# SAFETY RECALL

Sr08-21

DATE : NOVEMBER 2008	SECTION : 18-BODY
SUBJECT : REPLACING PASSENGER SEATS PEDESTAL ASSEMBLY FIXING SCREWS

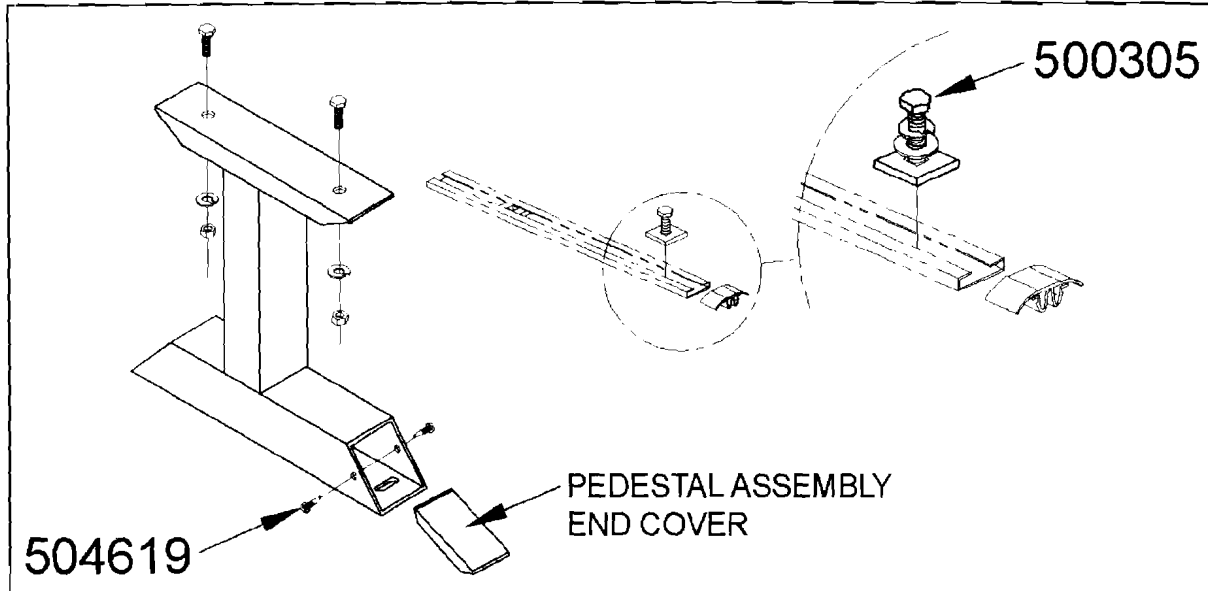
On vehicles affected by this recall, it is **absolutely necessary** to verify the screws fixing the passenger seats pedestal assembly to the floor rail system. There is a possibility that the manufactured screws were not of the proper quality and may break upon tightening or in use. If a "P" is present on the screw head, these must be replaced.

1. Remove pedestal assembly end covers.

2. Verify if "P" sign is present on cap screw head fixing pedestal assembly to the floor rail system.
3. If this is the case, these screws must be replaced with (500305) and torque tighten screw to 27 lb-ft.

4. Reinstall end covers and fix using "Christmas Tree" type fasteners (504619).
